Impact Assessment Report – Supplementary
Information

Six Mile Creek Dam Safety Upgrade Project

Prepared for Seqwater
29 March 2019

This supplementary information has been prepared in response to comments on the draft IAR which were received from the Office of the Coordinator General on 12 March 2019. This supplementary report should be read in conjunction with the IAR.

FIGURE 3-1: PROPOSED LOCATION OF BORROW PIT

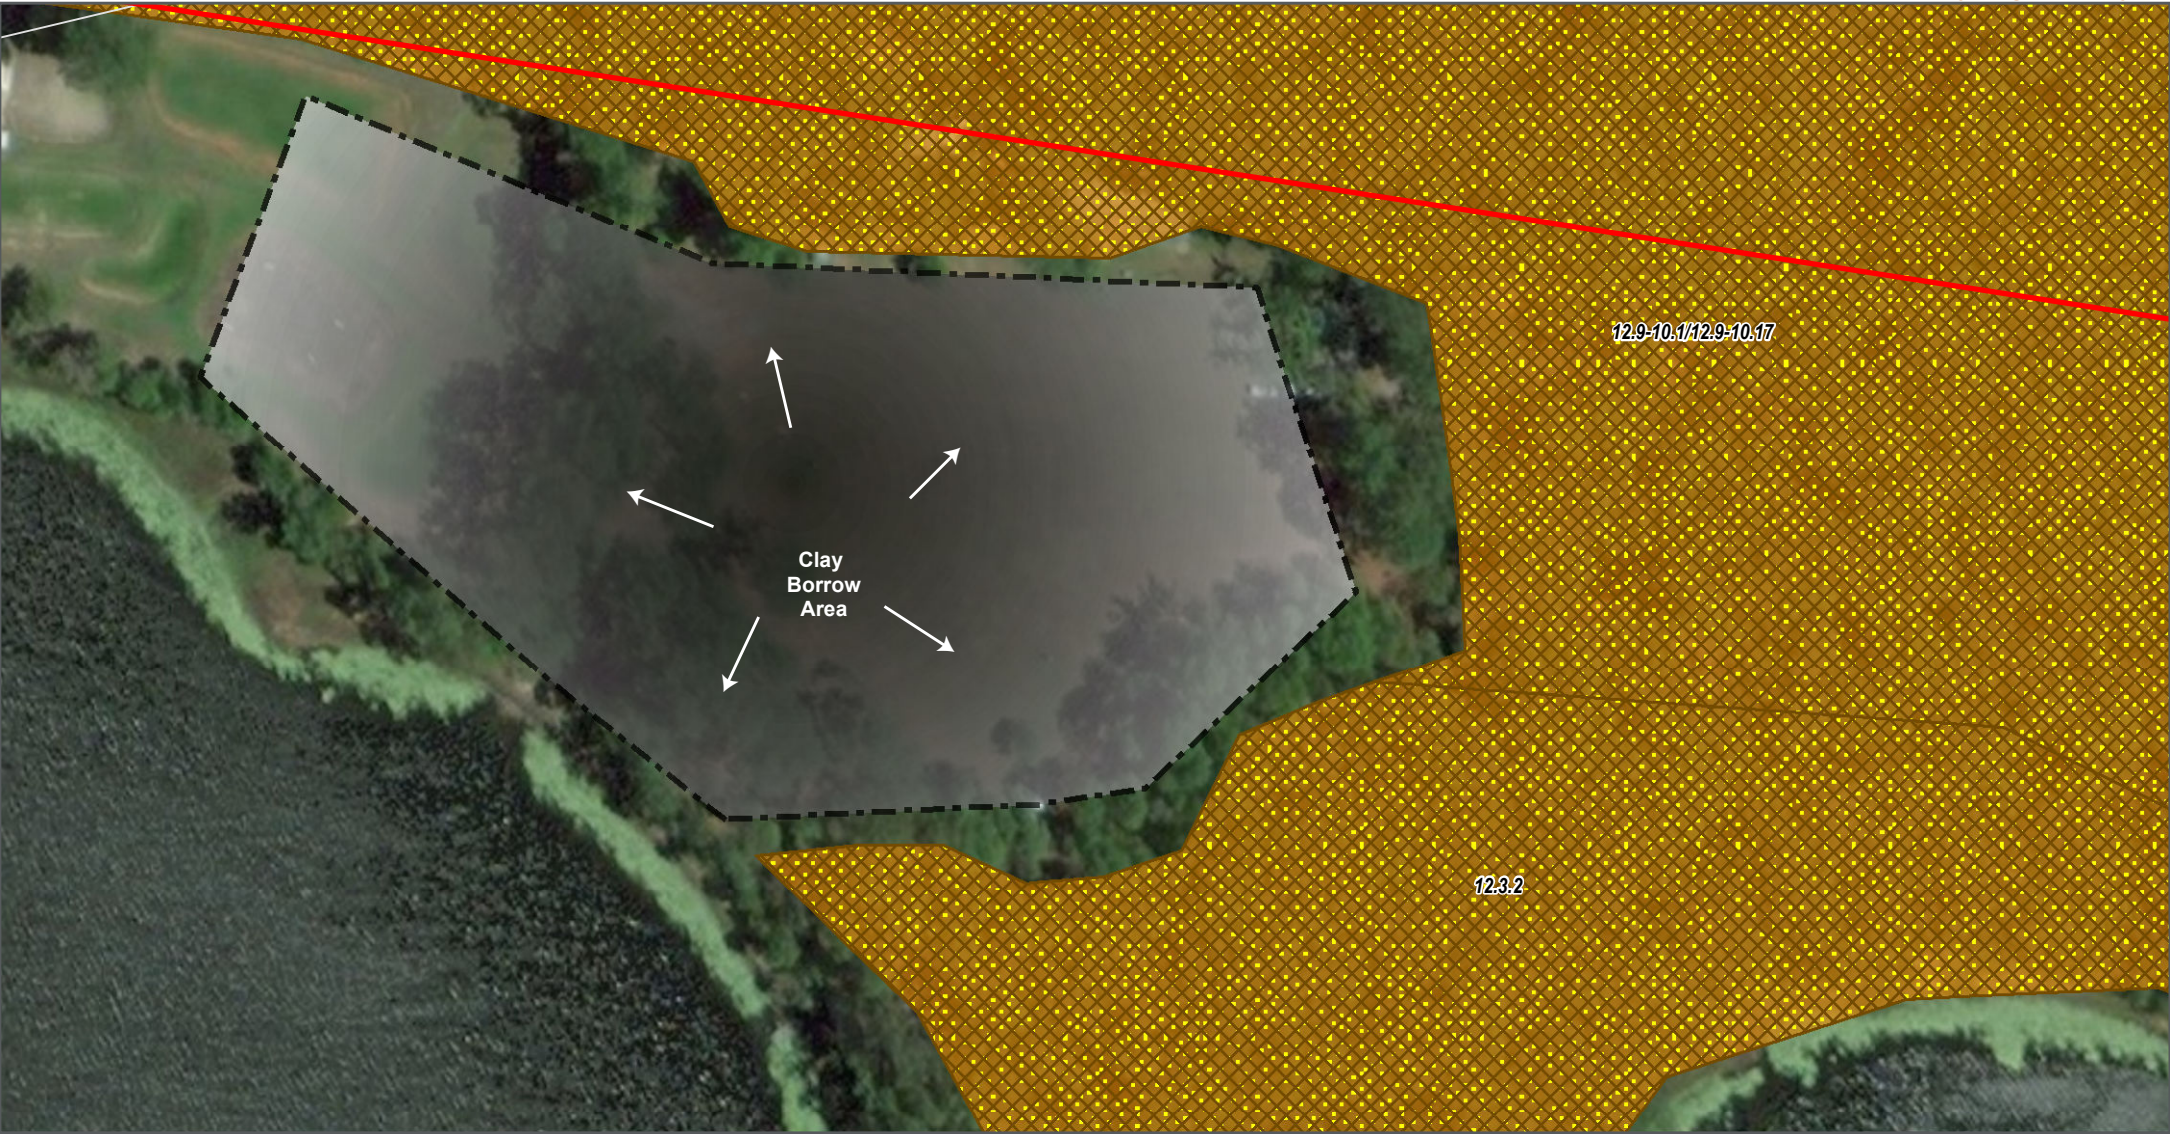
The draft EMP must clearly show a map outlining the extent of clearing proposed for the borrow pit as it is directly surrounded by MSES vegetation. Unintentional clearing is a possibility (and may incur offset requirements). The map provided in Figure 3-1 is not sufficient. A map must show the extent of the borrow pit, the extent of proposed clearing, access roads and demarcation of areas not to be cleared.

A map illustrating the maximum clearing extent has been provided in Appendix 1. An updated version of Figure 3-1 has also been provided in Appendix 1.

Note also that the GPS coordinates for the borrow pit, provided in the draft IAR (Table 3-3), will be confirmed in the construction planning phase and any optimisation will be reflected in updated GPS coordinates for maximum borrow area extent that are stated in the in the Environmental Authority approval conditions (ERA 16). Optimisation is expected to be of a scale that has no additional environmental impact.
